# A63 Castle Street Improvement, Hull

## DCO Documents Errata

TR010016/APP/6.1  
HE51408-MMSJV-GEN-S0-RP-ZH-000016  
~~10-20~~ September 2019

**ES Table 16.7: Significance of combined effects (revised)**

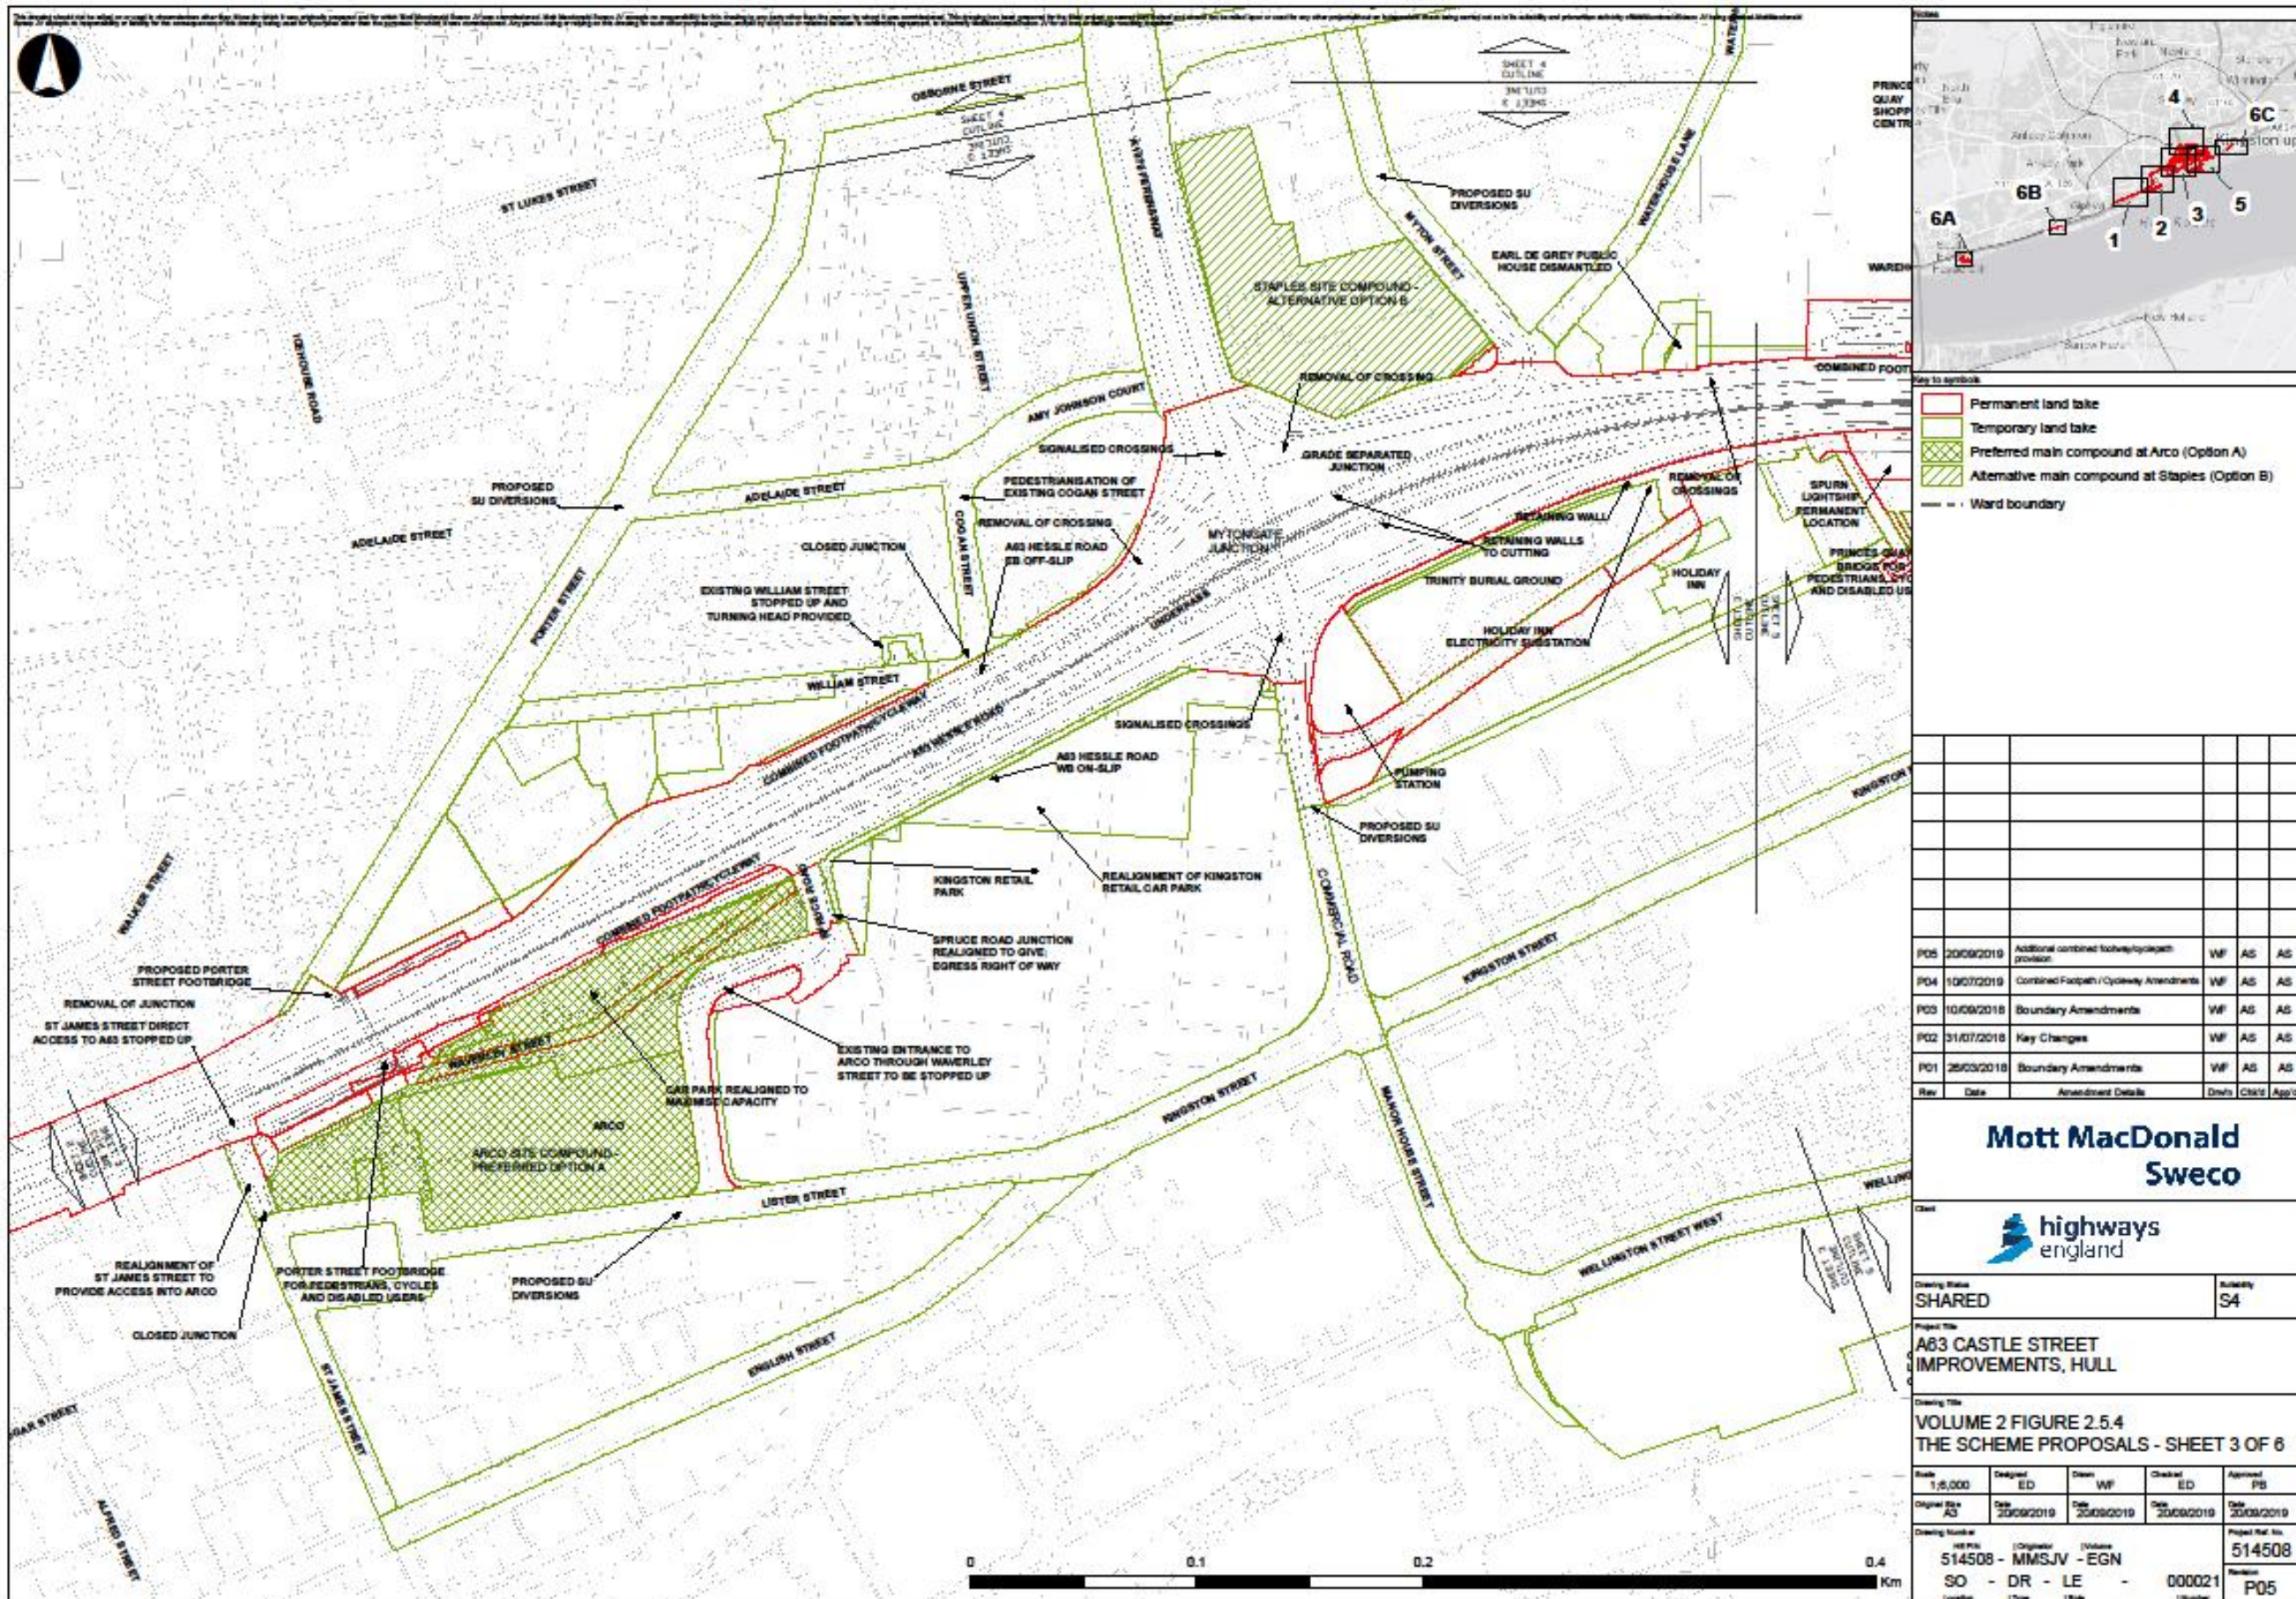
684	Table 16.7 Significance of combined effects	n/a	Replace Table 16.7 with revised Table 16.7 below as discussed in comments on WQ1.10.10. (new/revised text in red).

Drawing Title: **VOLUME 2 FIGURE 2.5.4 THE SCHEME PROPOSALS - SHEET 3 OF 6**

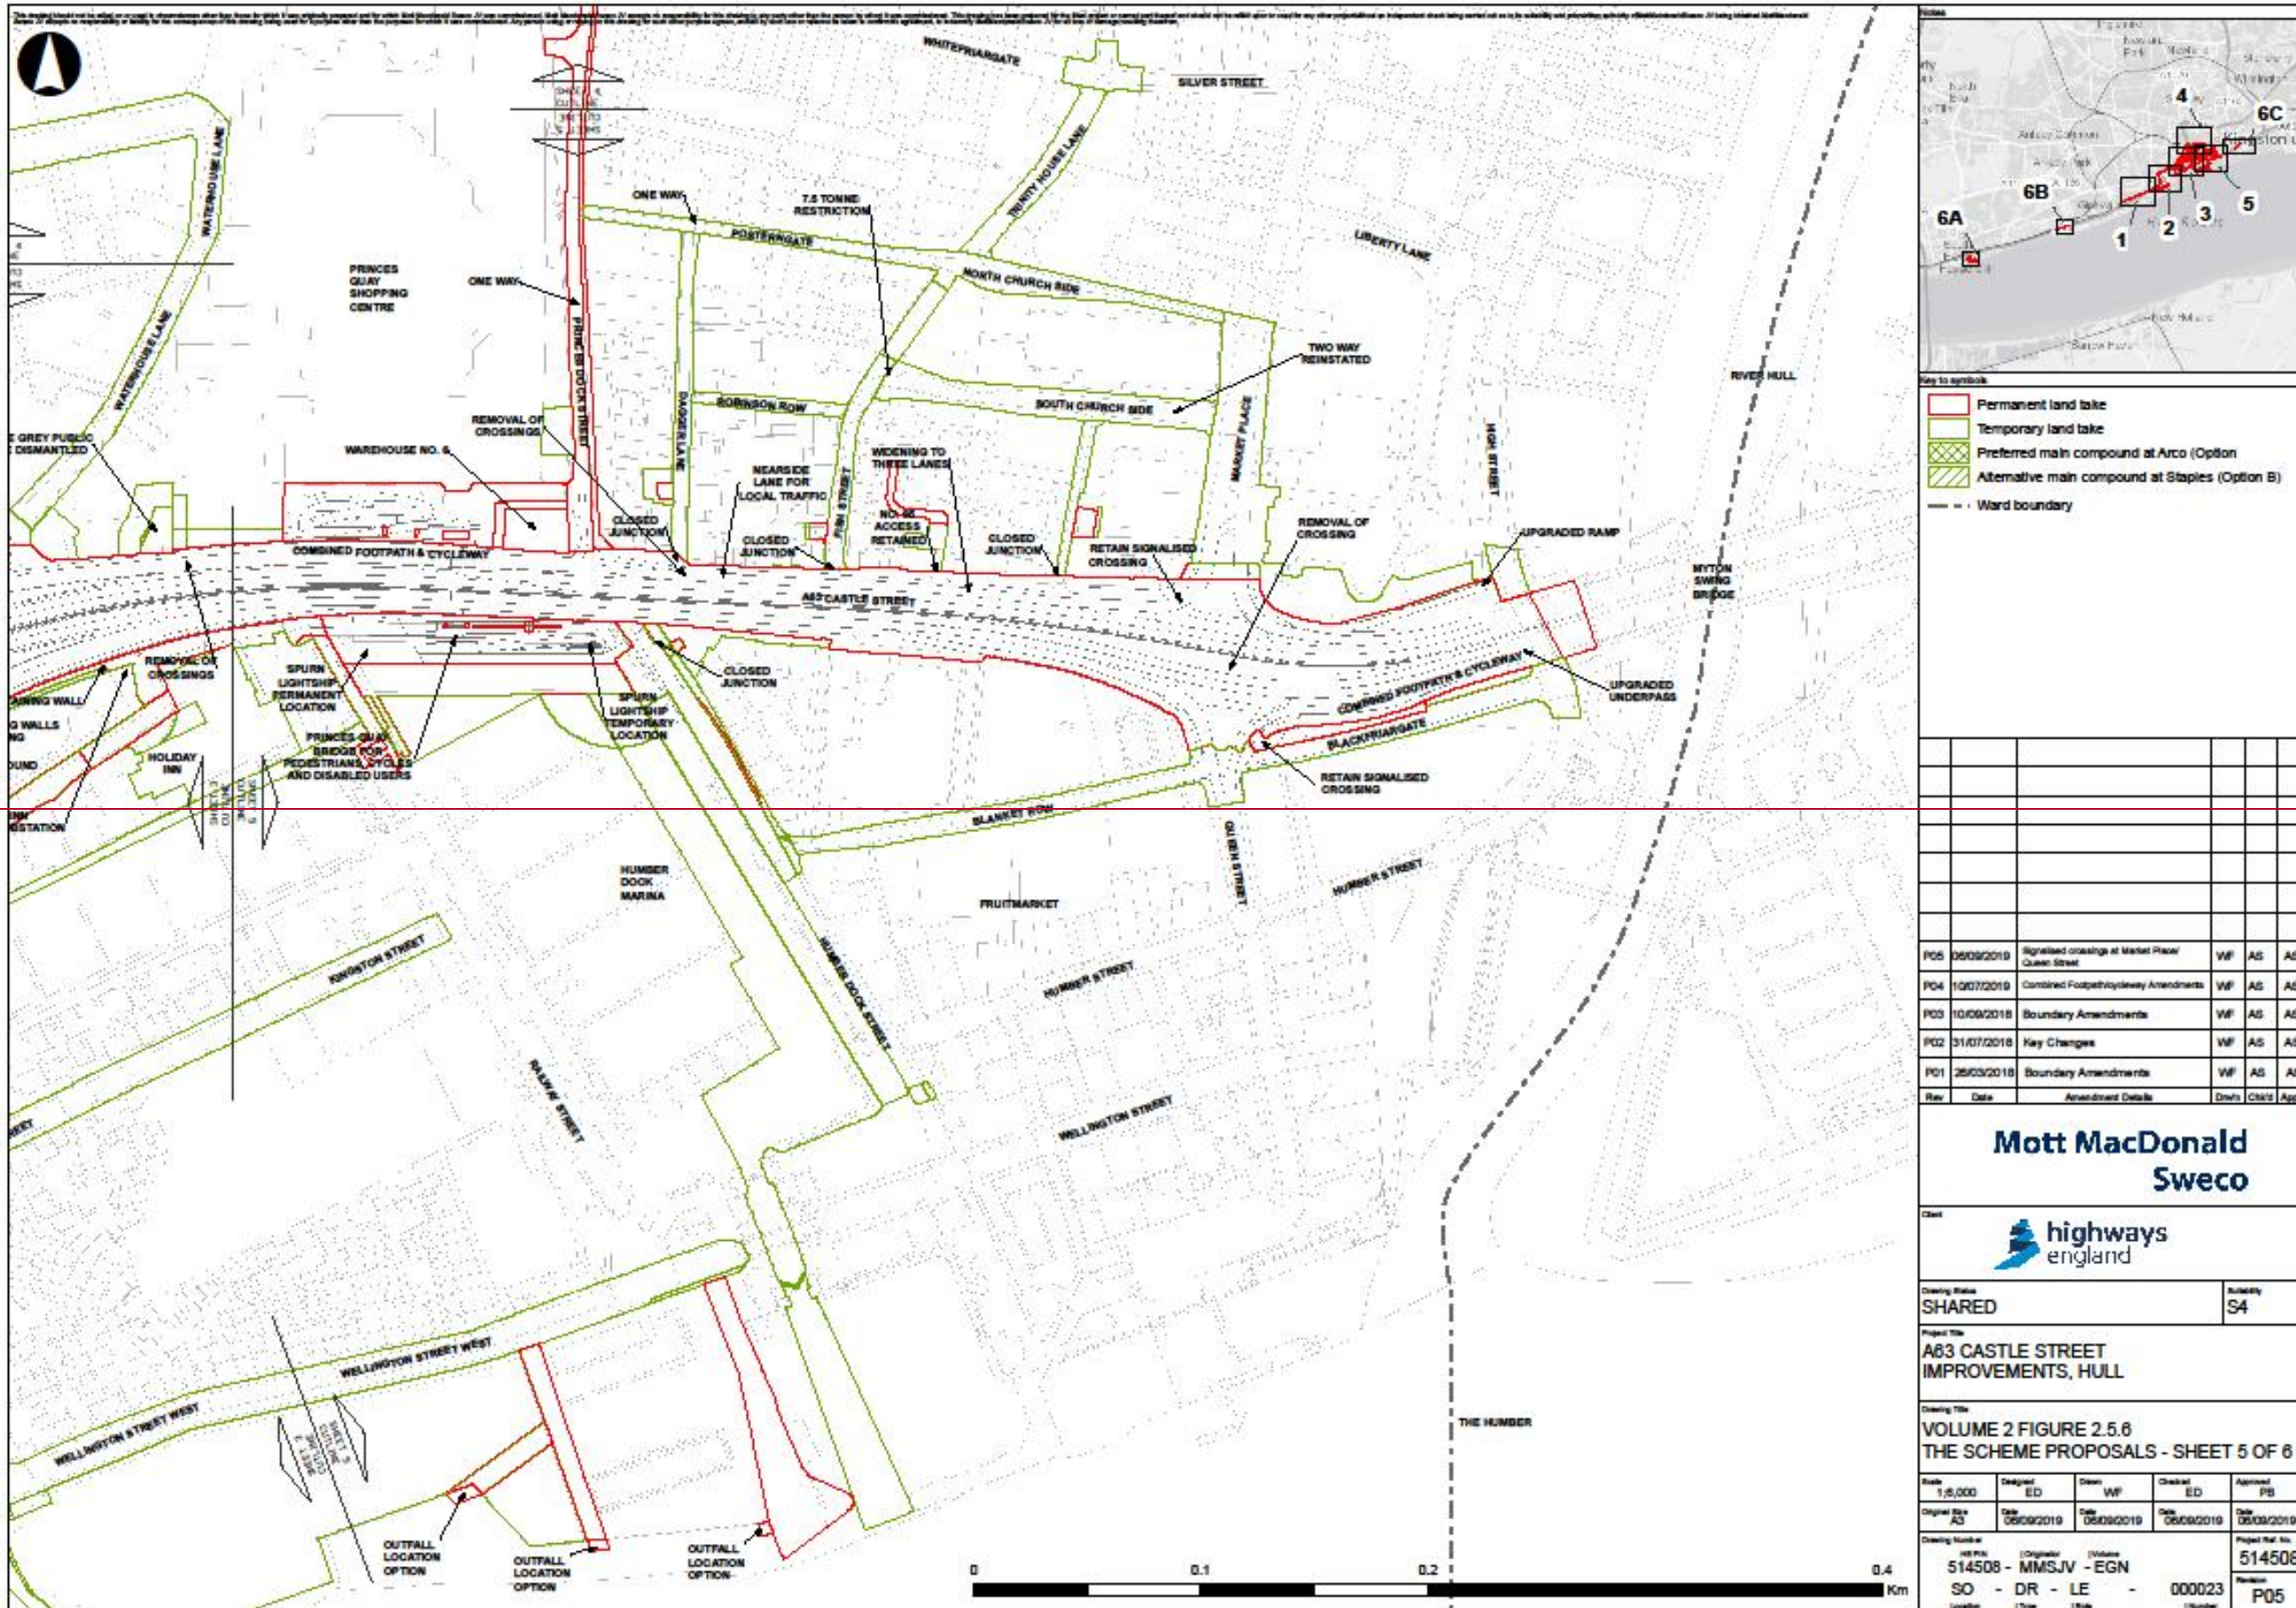
3.1.1 Replace ES Volume 2 Figure 2.5.4 The Scheme Proposals – Sheet 3 of 6 and Figure 2.5.6 The Scheme Proposals – Sheet 5 of 6 (APP-025) with the new Figures 2.5.4 and 2.5.6 below. Changes are as follows:

- Locations of the combined footpath & cycleway have been ~~clarified~~revised.
- Signalised crossings at Market Place and Queen Street are to be retained.
